ADDENDUM NO. 1

6/1/26

Water Main Relocation on St. Joseph Ave From 7th to 8th Street

Contract No. HU 2026-43

C
CW1.2

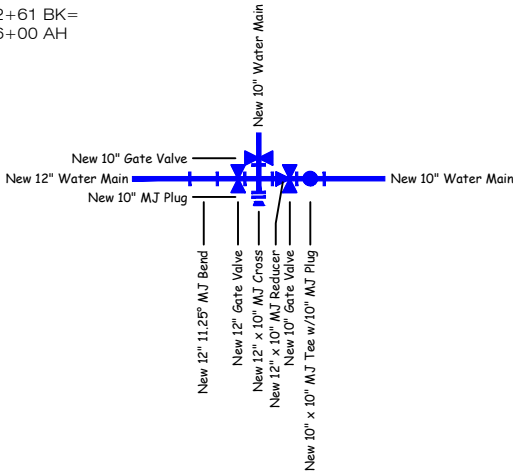
1. *Update Bid Opening Date* throughout the specification to **June 10, 2026 at 4:00 PM** to allow more time as a result of the following changes.
2. *Updated Plans and Proposal: Use the new proposal pages (Addendum 1) for bid submission.*
 - a. See the following update plan and project proposal to reflect changes.
 - i. Changes include: Upsizing from 10" to 12" pipe, fittings, and valves encompassing details C, D and I and interconnecting piping.
